# SUNSHINE COAST REGIONAL DISTRICT

Question and Answers #2

Request for Proposal No. 2337006

Dam Safety Improvement and Upgrades to Chapman, Edwards and McNeil Lakes

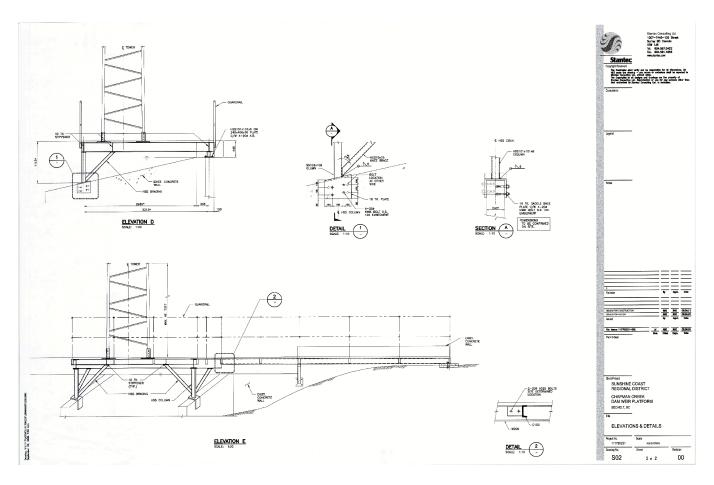
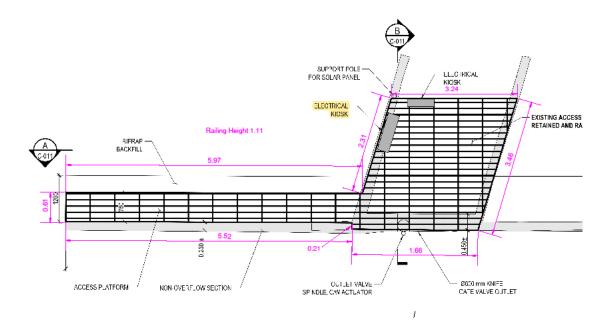
Question: Please provide shop drawings of the existing Access Platforms.

**Answer:** We do not have shop drawings for the existing platforms. The Edwards Lake Dam platform design can be found in Question 50. The two attached files following provide design drawings for the Chapman Lake Dam platform (note: the tower shown on the drawings was not constructed).

Photo of Edwards Lake Water Levels 2022

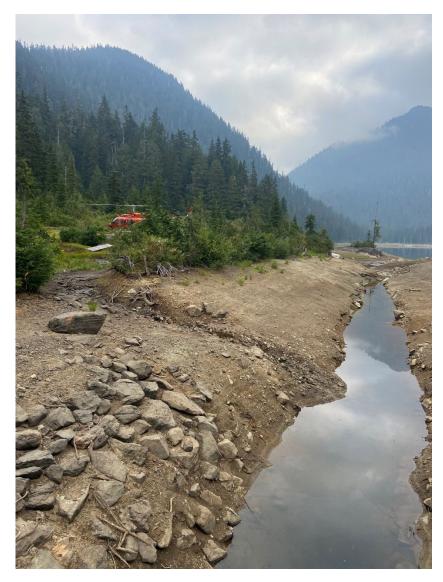
Question: Does the water level drop?

**Answer:** Yes, we do not guarantee how much the water level will drop please see the photos of last year's water levels.
